UNITED STATES PATENT AND TRADEMARK OFFICE

| APPLICATION NO. | FILING DATE | FIRST NAMED INVENTOR | ATTORNEY DOCKET NO. | CONFIRMATION NO. |
|--|-------------|----------------------|----------------------------|------------------------|
| 10/789,859 | 02/27/2004 | Kent Ashby | 15499.450.2 | 8490 |

Office Action Summary

DETAILED ACTION

Fig. 31

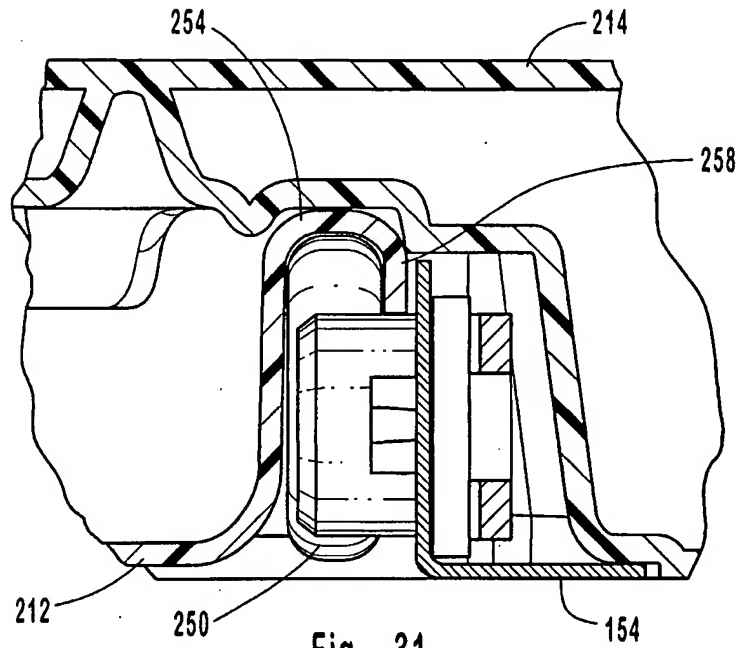
Acceptable!
HVT 6/8/08
